FORM APPROVED
OMB NO. 1004-0137
Expires: January 31, 2018**SUNDRY NOTICES AND REPORTS ON WELLS**
*Do not use this form for proposals to drill or to re-enter an abandoned well. Use form 3160-3 (APD) for such proposals.***SUBMIT IN TRIPLICATE - Other instructions on page 2**

Jenkins B Federal # 17

Jenkins B Fed # 17 WBD

**Permanent Abandonment of Federal Wells
Conditions of Approval (LPC Habitat)**

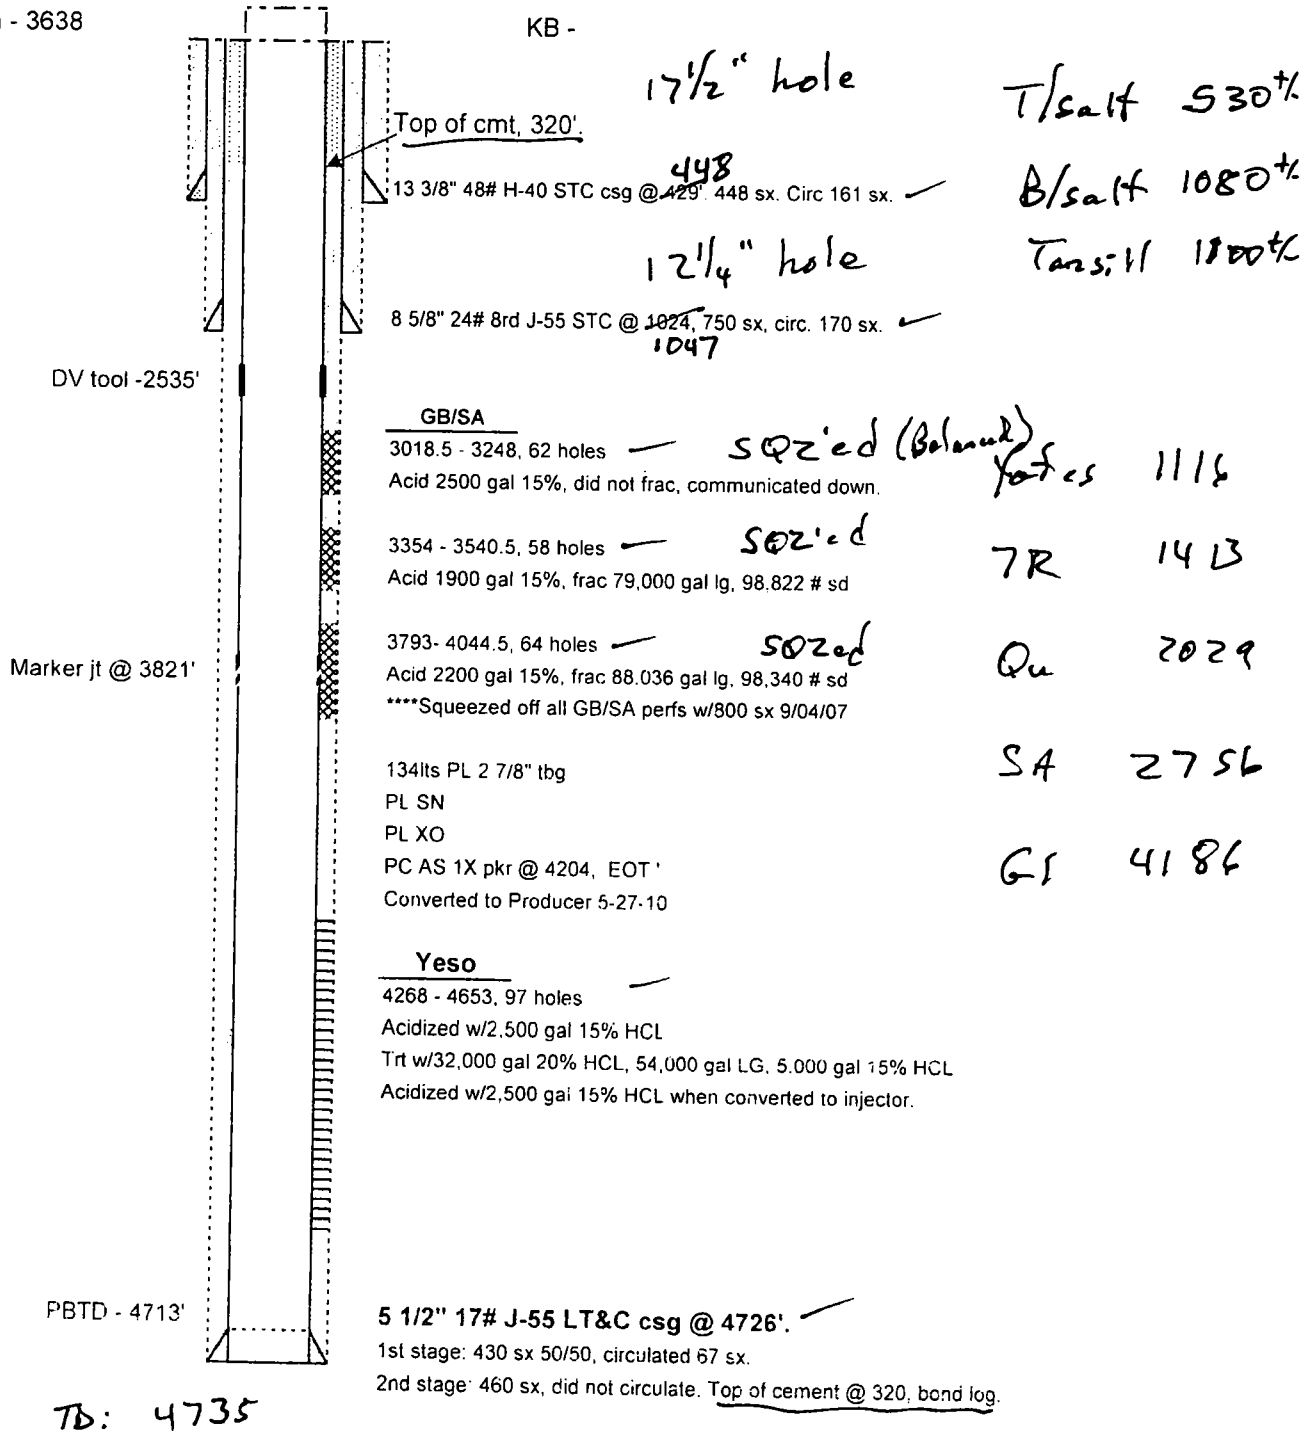
13. Describe Proposed or Completed Operation: Clearly state all pertinent details, including estimated starting date of any proposed work and approximate duration thereof. If the proposal is to deepen directionally or recompleat horizontally, give subsurface locations and measured and true vertical depths of all pertinent markers and zones. Attach the Bond under which the work will be performed or provide the Bond No. on file with BLM/BIA. Required subsequent reports must be filed within 30 days following completion of the involved operations. If the operation results in a multiple completion or recompletion in a new interval, a Form 3160-4 must be filed once testing has been completed. Final Abandonment Notices must be filed only after all requirements, including reclamation, have been completed and the operator has determined that the site is ready for final inspection. *Set CIBP @ 4218. Cap w/ 25 sx cmt. (Yes)*

- Set 5 1/2" CIBP @ 2970'. Circulate hole w/ MLF. Pressure test csg. Spot 25 sx cmt @ 2970-2870' 2700 (SA)
- Spot 25 sx cmt @ 2585-2485'. WOC & Tag (DV Tool) 2455 minimum
- Spot 25 sx cmt @ 1074-974'. WOC & Tag (8 5/8" Shoe) 1166-997 (Shoe and T/yates)
- Spot 25 sx cmt @ 479-379'. WOC & Tag (13 3/8" Shoe) 580-398 (Shoe and T/salt)
- Perf & Sqz 25 sx @ 100'-Surface.
- Cut off well head, verify cmt to surface, weld on Dry Hole Marker.

Below ground level dry hole marker required

** BLM REVISED ** BLM REVISED ** BLM REVISED ** BLM REVISED ** BLM REVISED **
